VIRGINIA ELECTRIC AND POWER COMPANY
RICHMOND, VIRGINIA 23261

In response to your letter of February 22, 1979, requesting additional information concerning the environmental qualification testing performed on the Continental Instrument Cable in use at Surry Power Station, we are providing the following information.

ATTACHMENT 1

ADDENDUM NUMBER 1
TO TEST REPORT IPS-383
COVERING
HAVEG INDUSTRIES, INC.
ANALYSIS OF INSTRUMENTATION
CABLE SAMPLES
FOR
VIRGINIA ELECTRIC AND POWER CO.

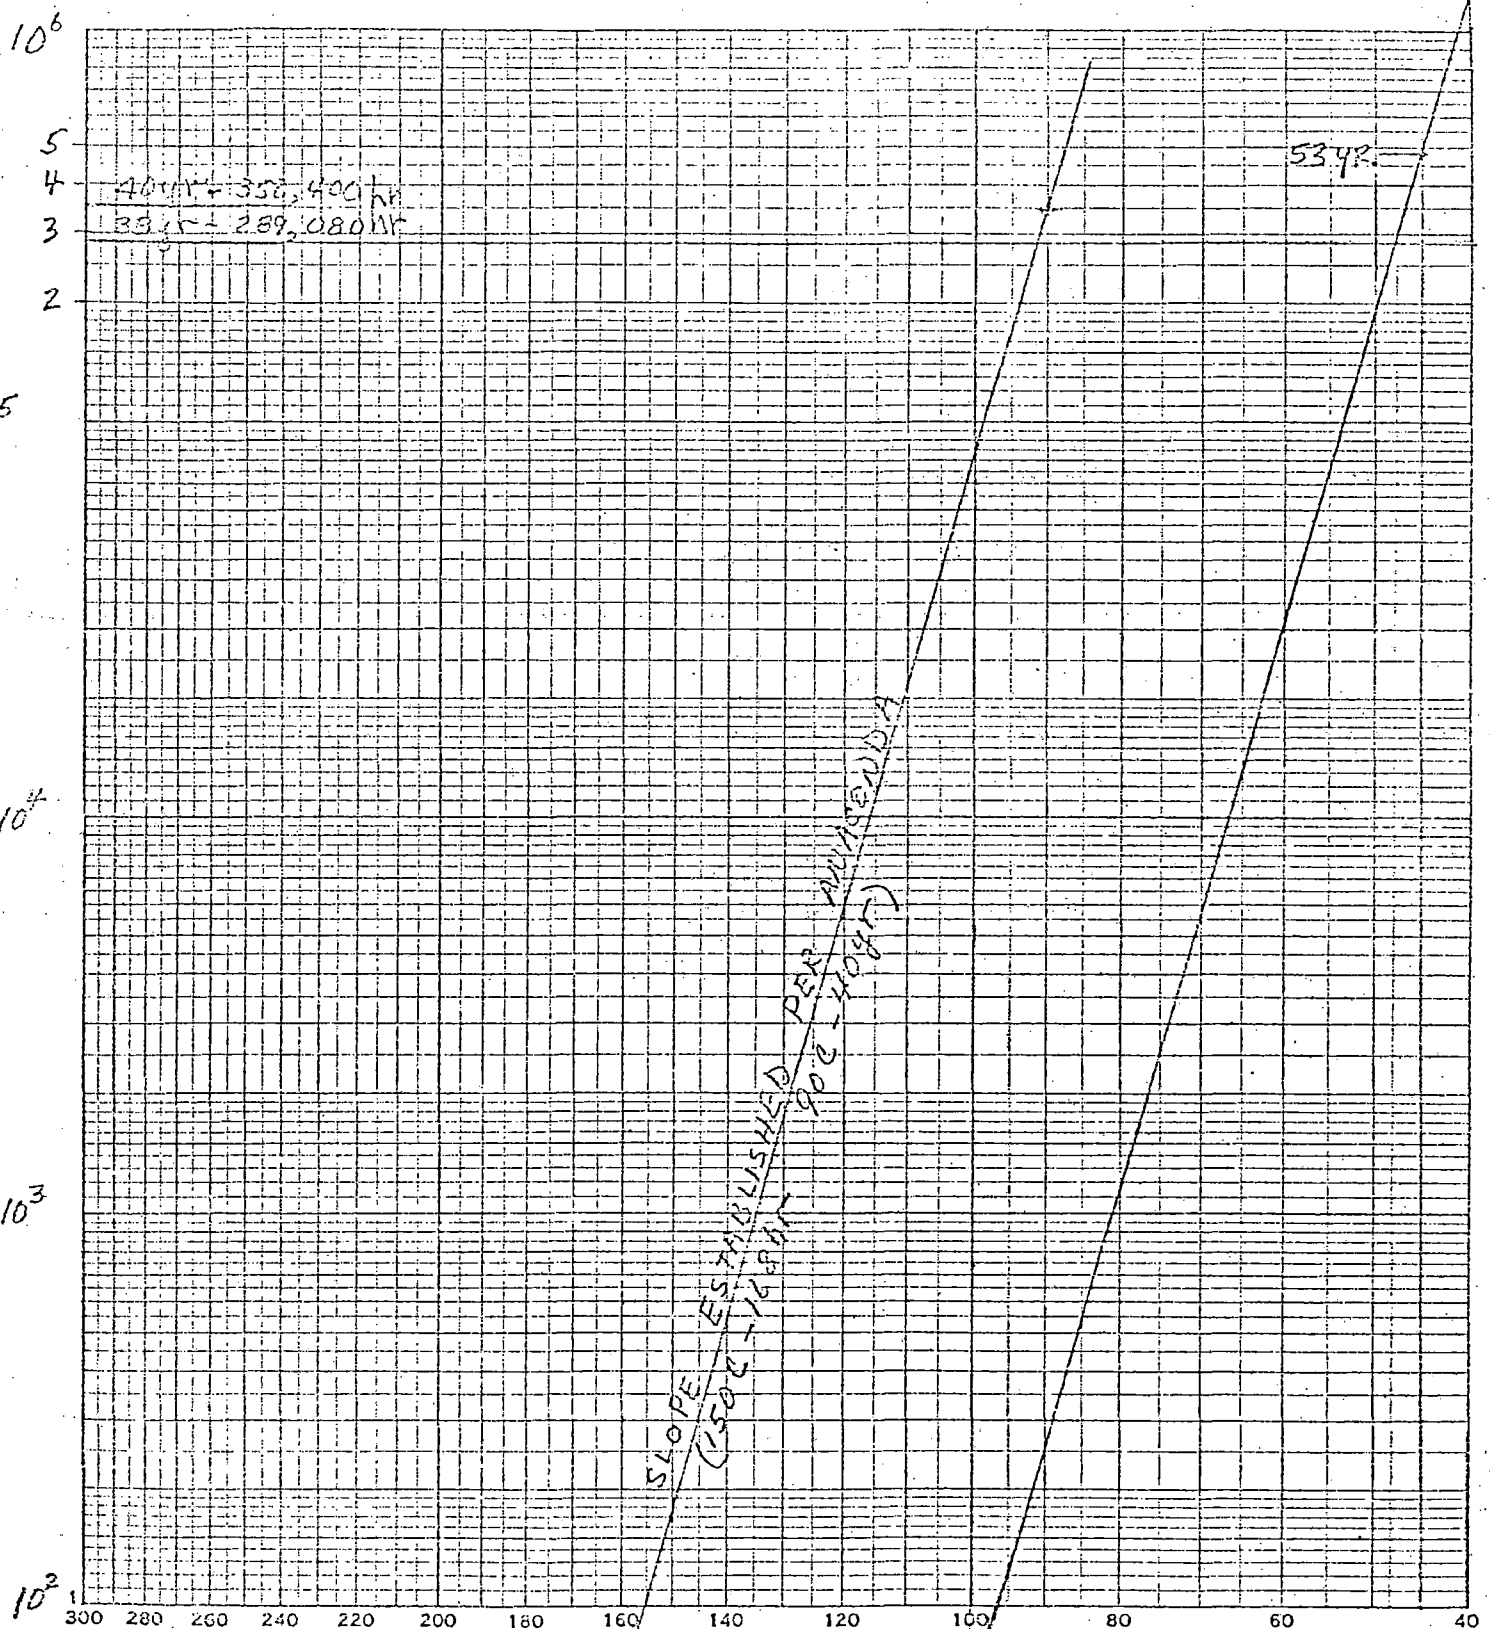
1. NRC request: Provide the basis for concluding that thermal aging of cable samples at 100°C for 60 hours simulates an additional thirty-three (33) years of in-plant use at a maximum ambient temperature of 50°C. These accelerated aging parameters were used in test sequence 1 on page 10 of the test report submitted with VEPCO letter dated December 15, 1978.

Response: We have reviewed data provided by the cable manufacturer, Anaconda/Continental, on the aging properties of its cross-linked polyethylene compound, CC-2210. This material was used for the insulation of the subject instrument cable installed at Surry. Data on the aging properties of this material are shown on attachment 1 in the form of an Arrhenius curve, the slope of which was determined using aging points of 90°C for 40 years and 150°C for 168 hours.

The thirty-three years of accelerated aging was based on a nominal forty year plant life minus the seven years the cable sample was in use. The test sample was subjected to an accelerated aging of 100°C for 60 hours to simulate thirty-three years of in-plant aging.

To translate 60 hours at 100°C into equivalent lifetimes at different temperatures, a line is plotted on attachment 1 parallel to the line representing the manufacturer's data through the 60 hours at 100°C point. The cable can be considered to be at ambient temperatures due to negligible I²R losses since the cable is used for instrumentation. Containment average bulk air temperature is 40°C (see note below). From the line plotted, it is seen that at 40°C, a 150-year life is indicated and at 45°C, a 53-year life is indicated. Thus, the aging process used is judged to be acceptable.
